Development Plan Amendment (DPA) 11-4 Arlington Road Post Office - Bethesda

Applicant: Keating Project Development, Inc.
 Prop. Address: 7001 Arlington Road, Bethesda
 Zone: PD-44
 Master Plan: Bethesda CBD Sector Plan
 Filing Date: August 30, 2011

The applicant, Keating Project Development, Inc., seeks an amendment to an approved 2008 development plan. The proposed amendment will reduce the amount of commercial space on the site from 30,000 square feet to 7,000 square feet and increase the number of dwelling units from 105 to 145. The amendment does not change the previously approved building volume and massing or site layout (including building height and scale, setbacks, open space, and access points). The reduction in commercial space is largely necessitated because USPS, an originally proposed tenant, continues to consolidate facilities across the country and no longer wishes to keep this facility in Montgomery County. Despite the reduction in commercial space, the applicant still proposes to provide street-lining retail along Arlington Road to help further activate the roadway. However, removing the originally approved USPS workroom causes a 23,000 square foot decrease in c

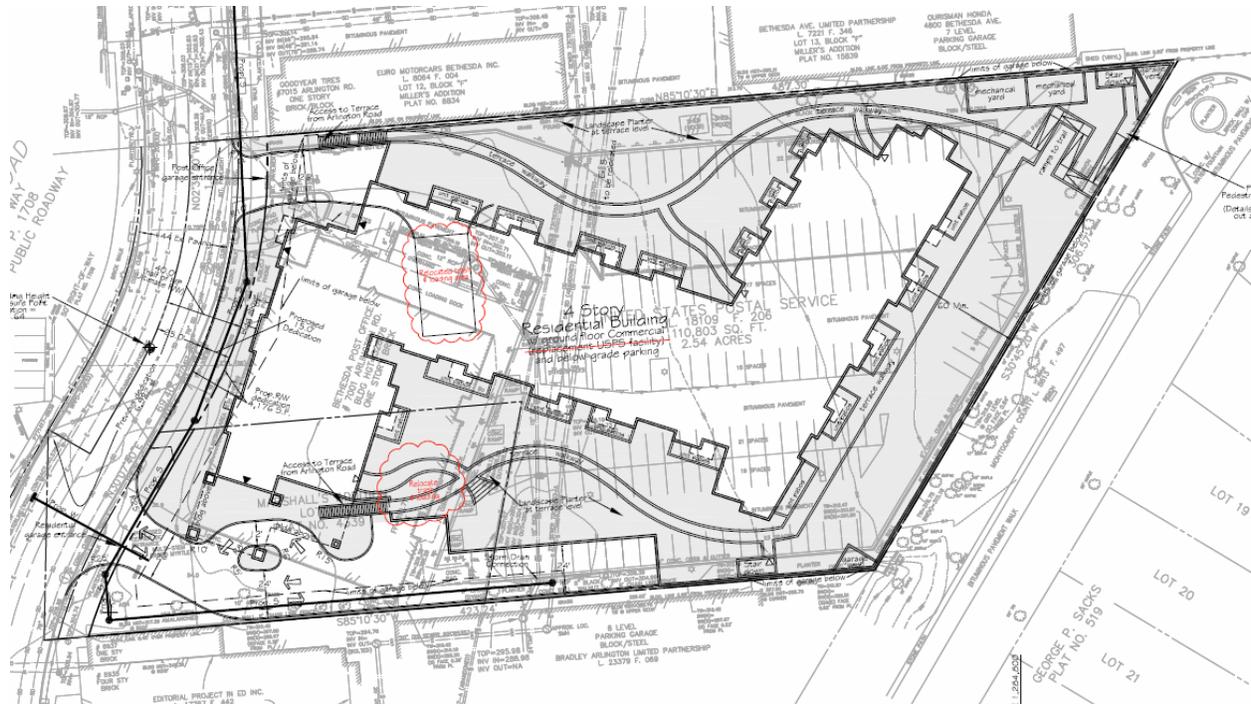
Incorporating the above changes, the applicant now proposes a five-story, mixed use development consisting of multifamily residential and street-lining retail in a single building along Arlington Road. The residential component will have a maximum of 145 multifamily dwelling units, including 15 percent MPDUs. The maximum building height along Arlington Road will be 59.9 feet. The front façade of the building faces the Arlington Road streetscape, which will be enhanced during site plan review to provide a wide, pedestrian-friendly urban sidewalk at the subject property. The ground floor will contain 7,000 square feet of retail space at the front façade of the building, with a parking structure comprising the remaining ground level. Due to the grade of the site, the retail along Arlington is at-grade, while the parking structure transitions to below-grade behind the retail storefronts. Therefore, parking and loading activities are provided below-grade, behind the retail storefronts and under the residential units, so associated trips and activity levels will have minimal impacts to pedestrians along Arlington road, trail users, or nearby residents of the Sacks neighborhood. The exterior wall of the parking structure will extend nearly to the rear property line adjoining the Capital Crescent Trail but will be almost fully underground. The originally approved lower level of the parking structure will be removed. The visible floors of the building will be set back 60 feet from the Capital Crescent Trail, creating a significant area for landscaped open space bordering this heavily trafficked portion of the path.

The ground-level will serve as a platform for the four-story residential portion of the building. The residential portion of the building will cover a roughly Z-shaped area of the parking facility roof, with two short wings parallel to Arlington Road and the Capital Crescent Trail, and a longer wing connected on the diagonal. The rest of the parking facility roof will be covered by landscaped terraces to comply with the PD Zone requirement that 50 percent of the site be occupied by green area. The terraces will be common space for building residents and will be accessible from the first floor of the residential portion of the building. The main entrance to the residential building will be at ground level, at the southern corner of the building's Arlington Road façade.

The walls of the four residential stories are specified to be 60 feet from the rear property line, not including patios or terraces. The 60-foot rear buffer is comprised of amenities consisting of patios, walkways and landscaped terraces gradually sloping to the Capital Crescent Trail. The elevation from the trail to the base of the residential building is approximately eight feet above the Capital Crescent Trail. As shown during the 2008 hearings, the proposed building will have no shadow impact on the Capital Crescent Trail, even during the time of the longest shadow at the winter solstice. If the amendment to the development plan is approved, the landscaped rear yard of the 60-foot buffer will be carefully articulated during site plan review to be a visually appealing amenity for users of the Capital Crescent Trail.

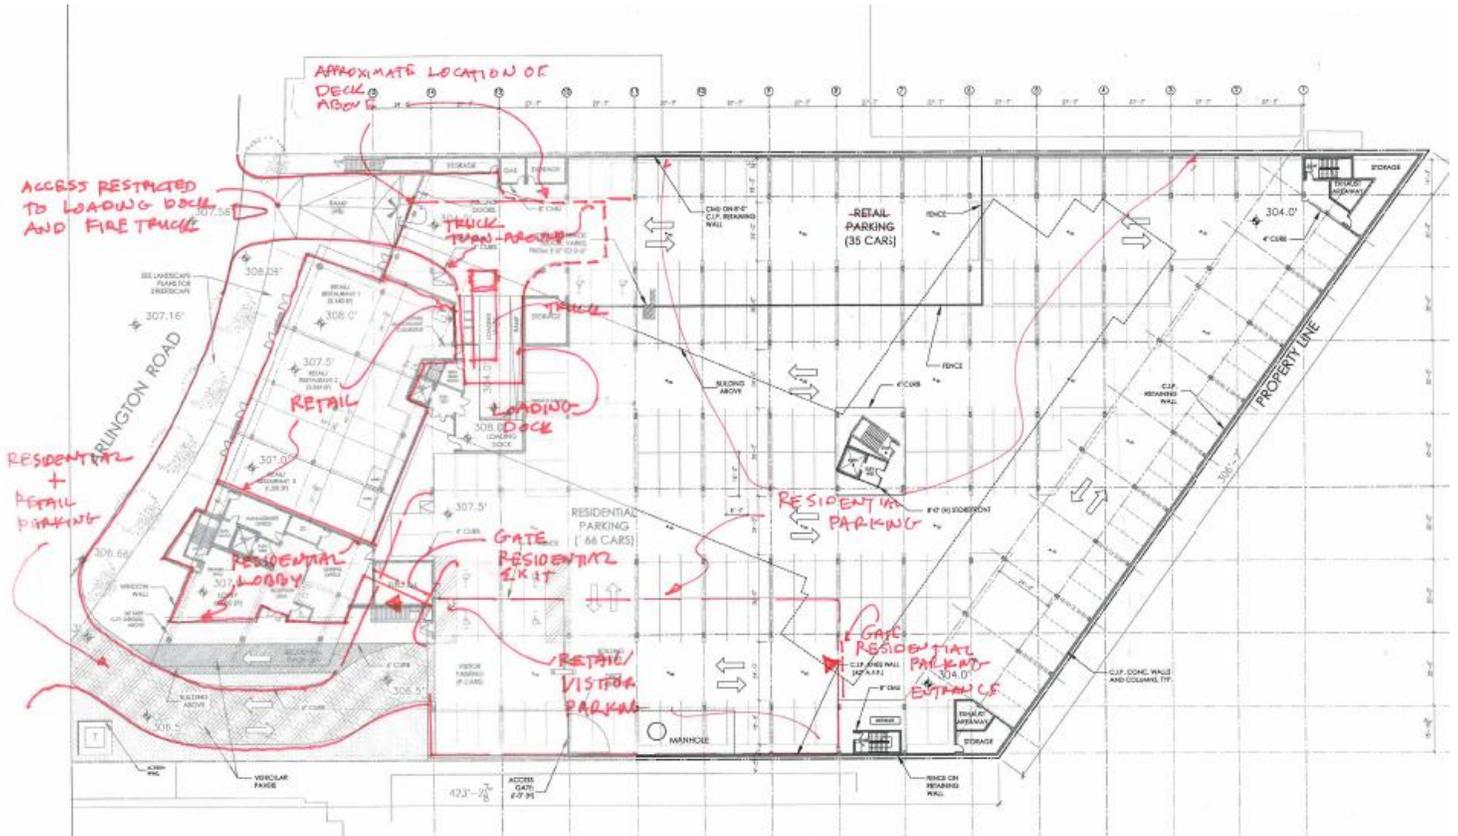
The approved development plan for the site with a 30,000 SF Post Office and 105 multi-family dwelling units was estimated to generate 273 peak-hour trips during the weekday morning peak-period and 359 peak-hour trips during the evening peak period. The approved development plan also included two driveways to the site, a southern driveway (across from the northern Bradley Boulevard Shopping Center driveway, at a new signal) for residents and postal employees and a northern driveway (at the existing driveway location) for postal customers and postal service vehicles.

The proposed DPA substantially reduces the commercial/retail area proposed on the site, which will result in minimal commercial/retail peak-hour trips to and from the site during weekday peak periods (five total trips during the morning peak-hour and 18 total trips during the evening peak-hour). In addition, the 145 multi-family dwelling units proposed on the site are estimated to generate 44 total peak-hour trips in the morning and evening peak-periods. Trip generation associated with the uses proposed under the DPA therefore represents approximately an 82 percent reduction in peak-hour trips during the morning and evening peak periods.

Thus, in consideration of the significant reduction in site-generated peak-hour trips resulting from the reduction in commercial/retail density on the site from 30,000 square feet to 7,000 square feet, change in the on-site commercial use from a neighborhood serving USPS post office to local-serving retail, and the Sector Plan recommendations to “provide vehicular access to Arlington Road from the south-west corner of the site”, the applicant will limit primary access to the site to a single driveway across from the northern Bradley Boulevard Shopping Center driveway. The applicant agreed to limit primary access to the site via the northern driveway after consultation with planning staff.

Truck loading and unloading will be provided in a driveway off Arlington Road to the northwest corner of the site to serve the needs of both the commercial and residential use(s) on the site. Staff will give the loading area significant review at the time of subdivision and site plan. Staff supports the continued existence of the northern driveway based on a finding that the driveway will be solely used for the intended purpose of truck loading and unloading in areas designated, will be designed and signed as such (including curb-cuts), and will not be used or blocked by any other vehicles (other than emergency vehicles).

The Sector Plan recommends pedestrian and bicycle access from the site connecting to the Capital Crescent Trail. The Sector Plan's suggested layout for the site shows an arrow from the site to the trail, pointing only in one direction. As suggested by the applicant, the Sector Plan likely would have shown a two-way arrow if the plan proposed public access from the trail to the subject site. Further, the applicant has concern that public access through the site could present security and liability concerns, and is inefficient due to grade elevation changes. Lastly, the applicant argues that allowing public access from the trail to the site will deflect pedestrians from traversing Arlington Road near the subject property, where activation will be encouraged with street-lining retail. In 2008, the Council was persuaded that the Plan intended the trail access from the site be private.

Though a determination was made in 2008 that the Sector Plan recommended access to the Capital Crescent Trail for site residents only, given the preponderance of bicycle users within the Bethesda CBD and the need for a desirable mid-block connection from Arlington Road to the Capital Crescent Trail and

to Woodmont Avenue, it is recommended that the applicant (and the Planning Board) reconsider public pedestrian and bicycle access through the site between Arlington Road and Capital Crescent Trail.
